PAYSON ASSISED LIVING FACILITY
PAYSON, UTAH

ARCHITECTURAL SITE
PLAN

A0.1

South Haven Senior Housing – Payson

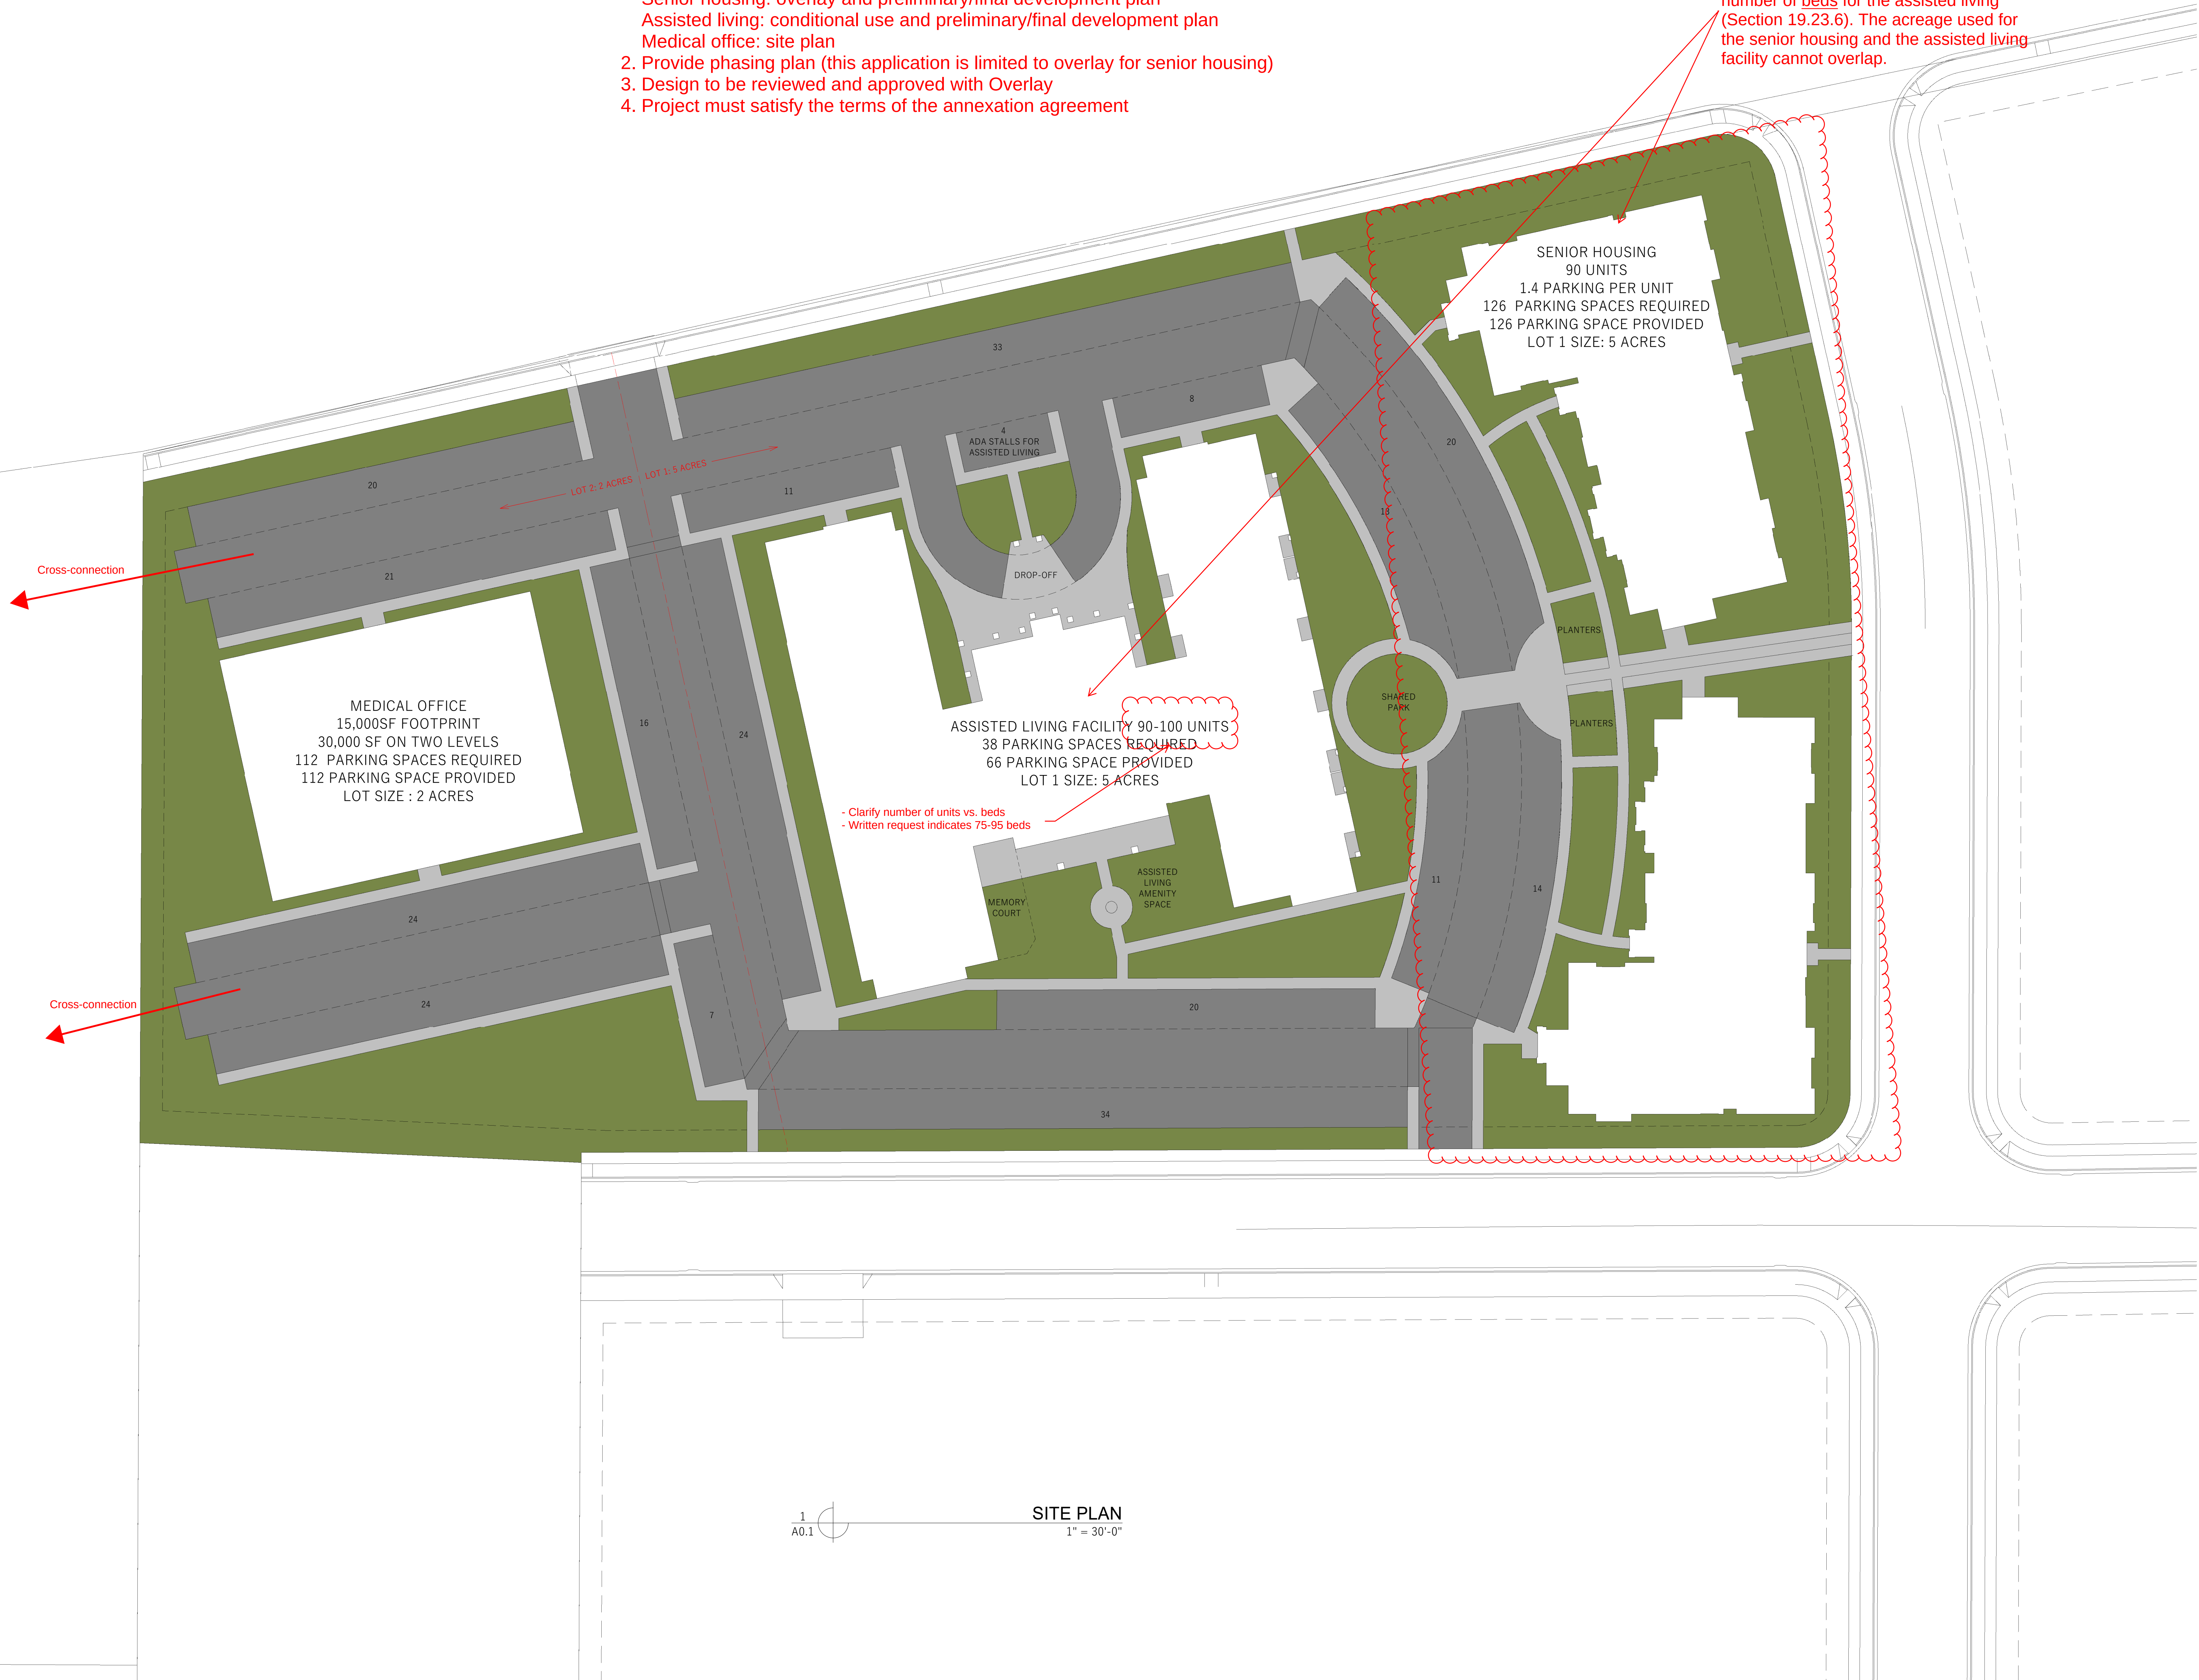
- Planning comments:
1. Required approvals:
Senior housing: overlay and preliminary/final development plan
Assisted living: conditional use and preliminary/final development plan
Medical office: site plan
 2. Provide phasing plan (this application is limited to overlay for senior housing)
 3. Design to be reviewed and approved with Overlay
 4. Project must satisfy the terms of the annexation agreement

Verify density calculations are consistent with Senior Housing Overlay and the number of beds for the assisted living (Section 19.23.6). The acreage used for the senior housing and the assisted living facility cannot overlap.

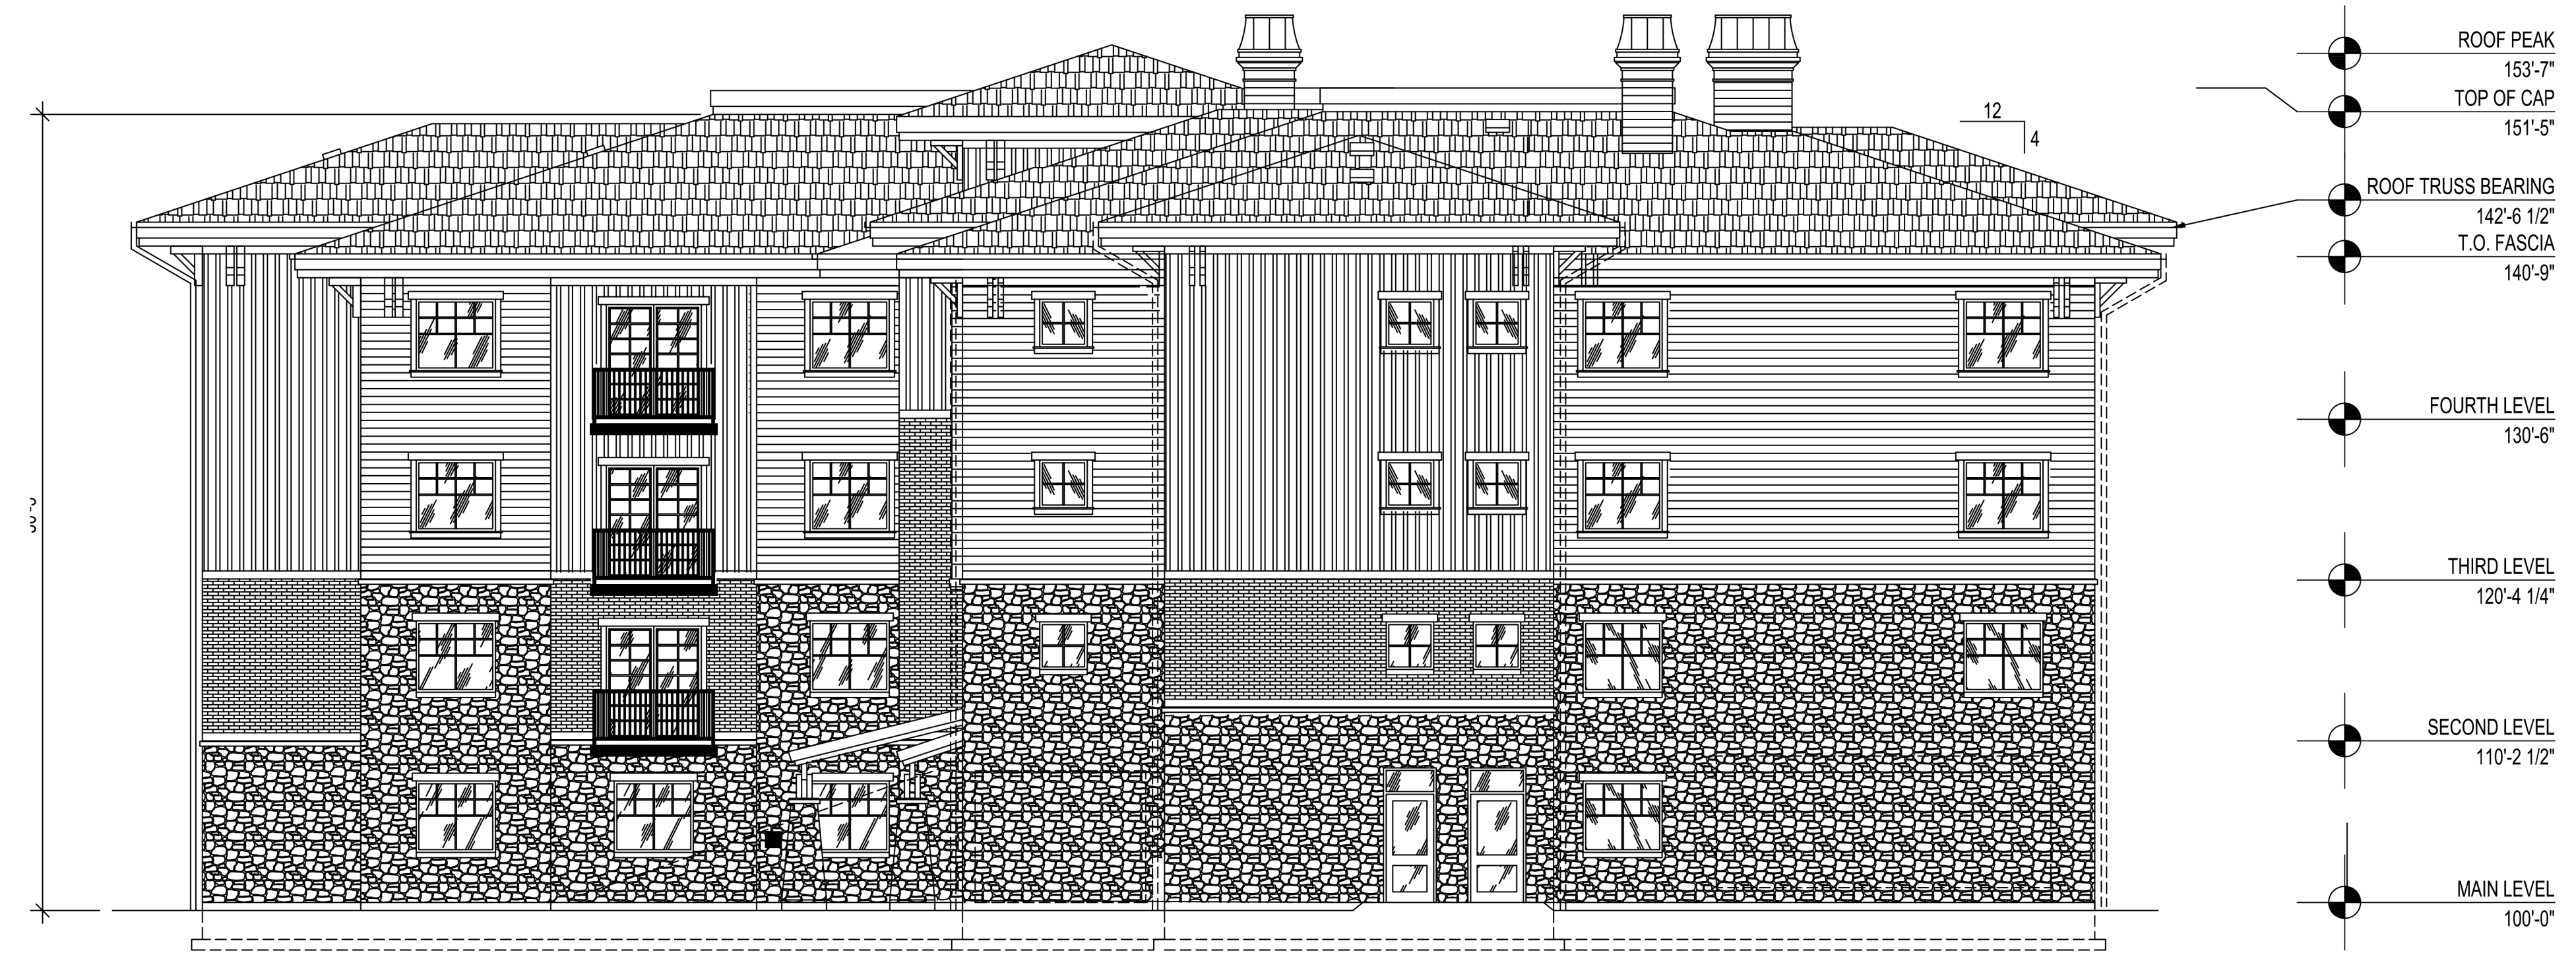
Provide pictures, elevations, etc. to establish expectations of all parties

Is the description consistent with ordinance regulations?
